ADDENDUM: ONE  
 ISSUE DATE: November 15, 2017  
 PROJECT TITLE: **INDEFINITE DELIVERY CONTRACT FOR SITE CONSTRUCTION SERVICES**  
 Francis Marion University  
 IDC Project No.: H18-D074-PD

Representative Project:  
**GAC ENTRY ROAD DRAINAGE PROJECT**  
**Francis Marion University**  
 IDC Project No.: H18-N070-PD

FROM: DDC Engineers, Inc.  
 James M. Wooten, PE  
 1298 Professional Drive, Myrtle Beach, SC 29577  
 sch@landartcompany.com

SCALE: 1" = 10'  
DATE: 9/28/17  
DESIGNED BY: SCH  
DRAWN BY: SCH  
APPROV. BY: JMW  
PROJECT NO.: 17103  
**HSCP-1**  
FILE NO.:

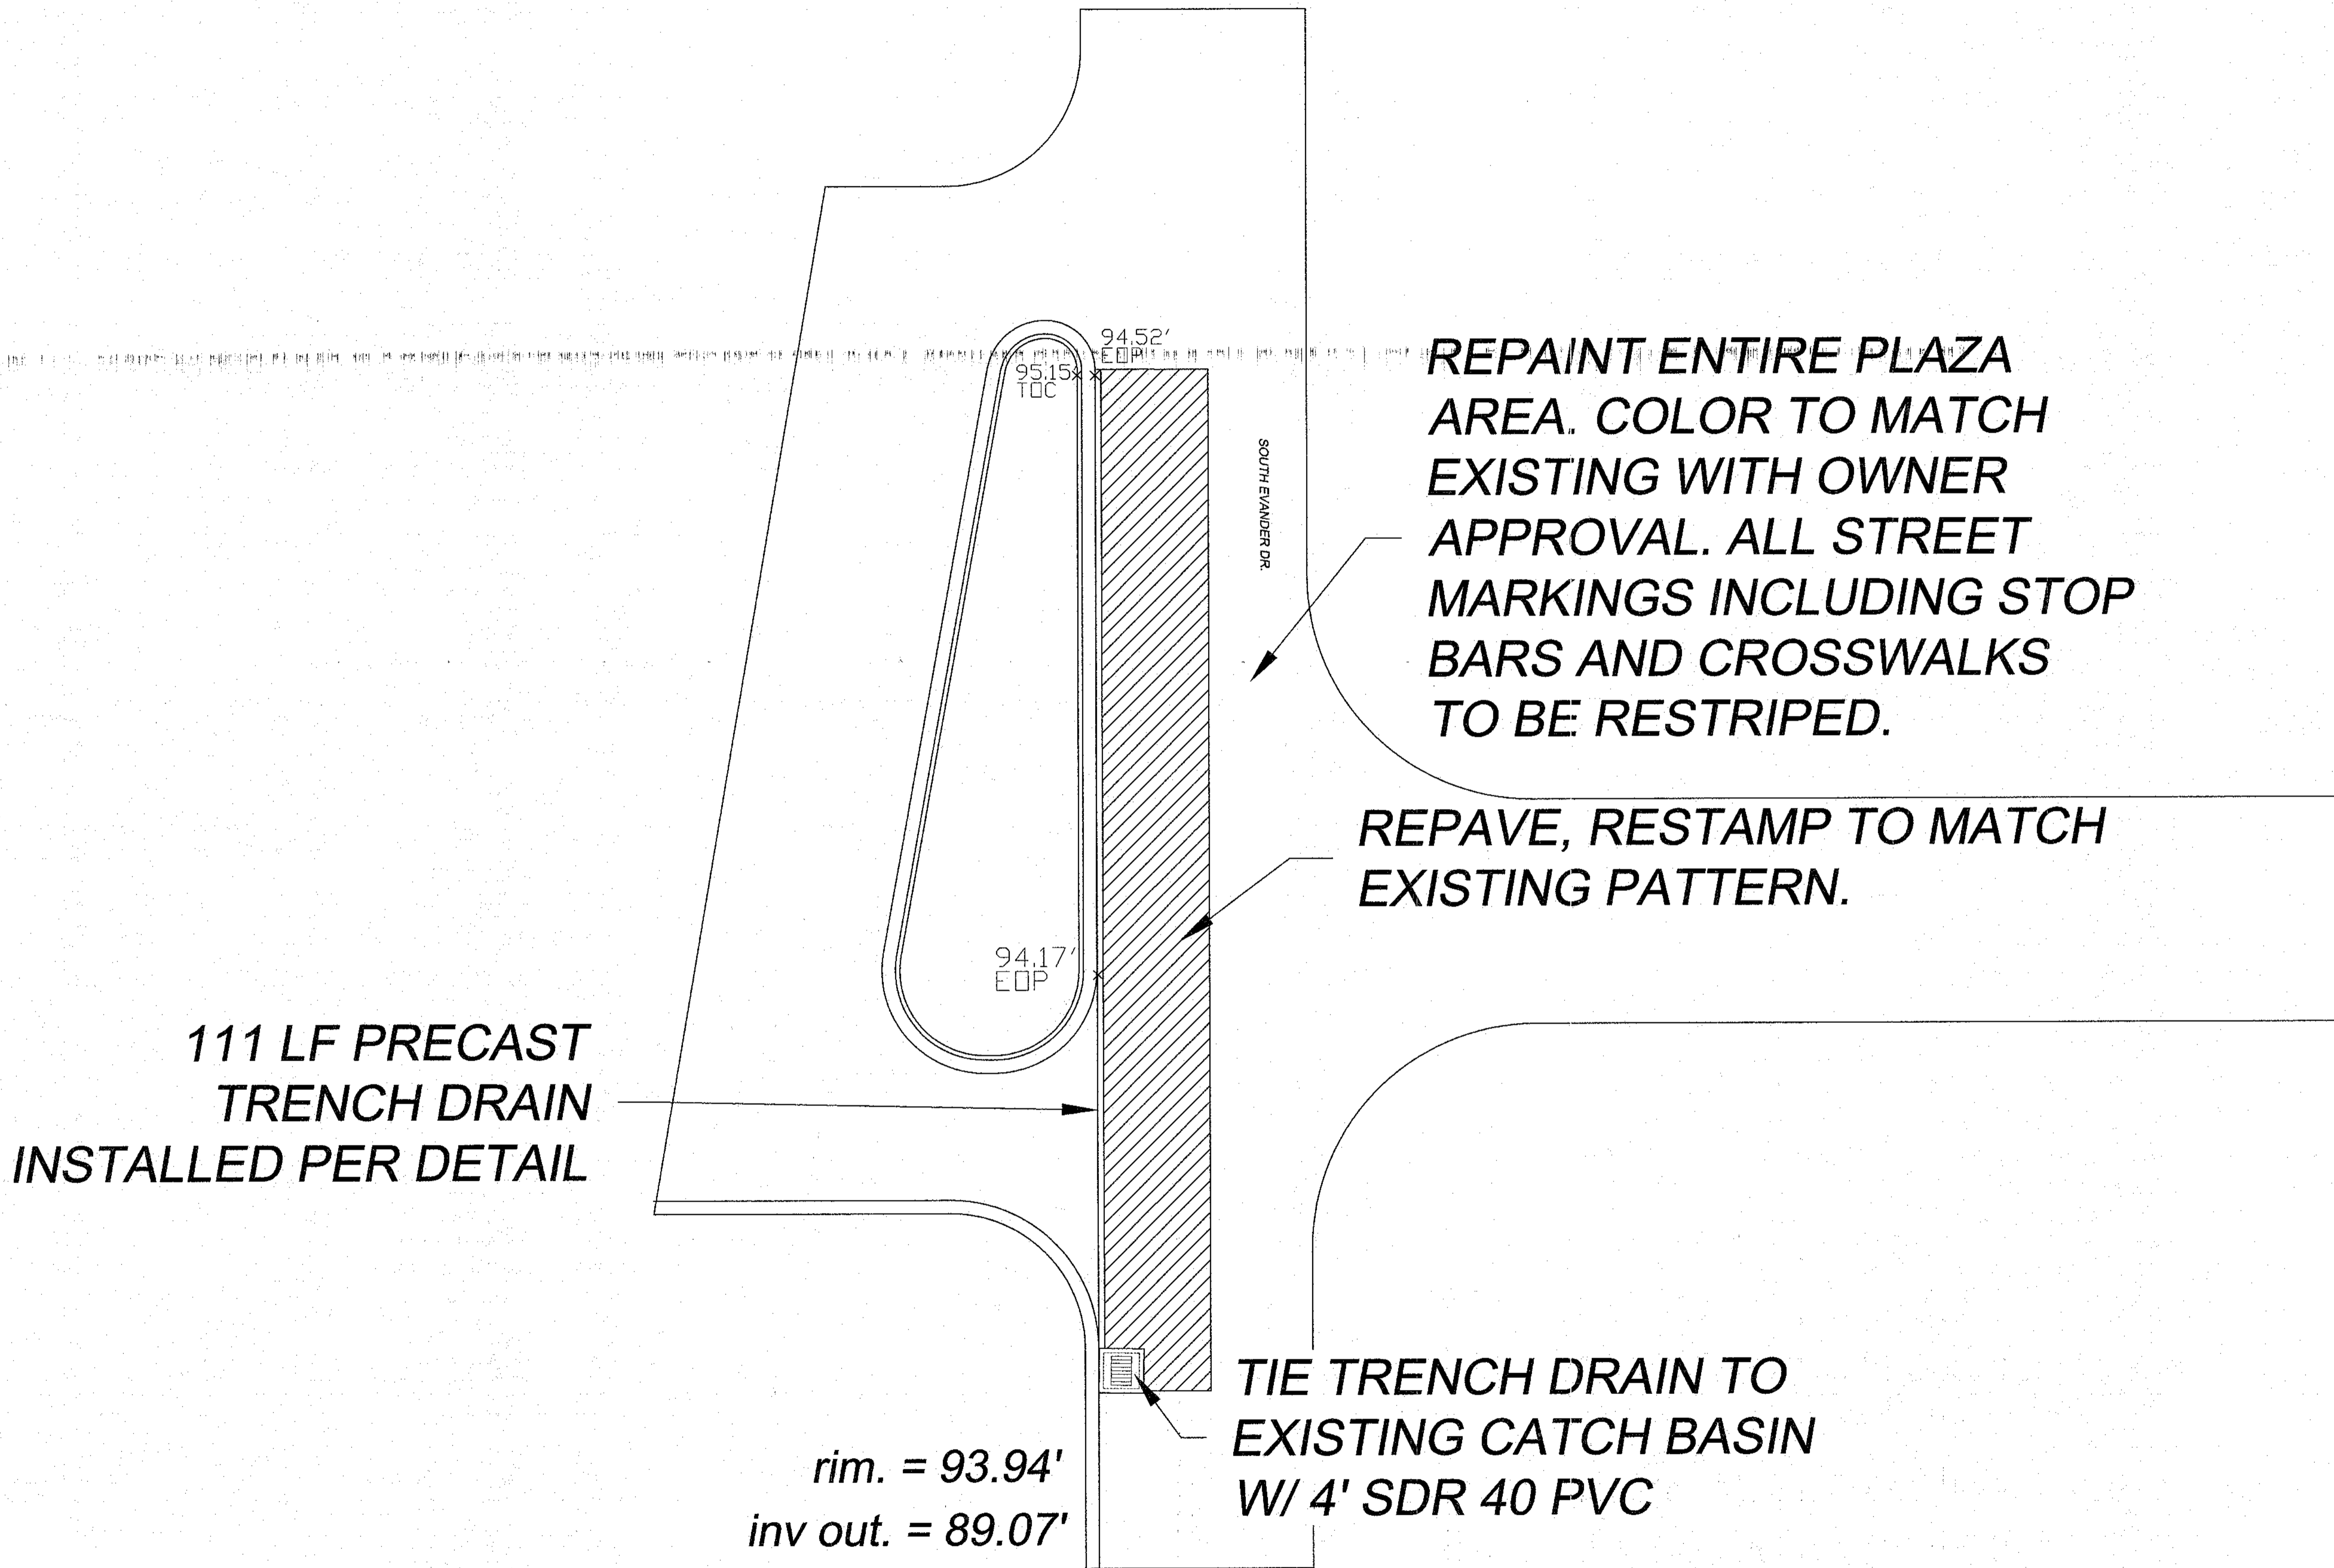
- D. Should include recoat entire stamped asphalt area and repaint stripping?

*Answer: Yes, Sheet HSCP-1 has been revised to depict the enlarge area to be repainted and restriped.*

**PRESSURE WASH ENTIRE PAINTED PLAZA AREA AT A MIN. 3,200 PSI AND REMOVE DEBRIS PRIOR TO PAINTING.**
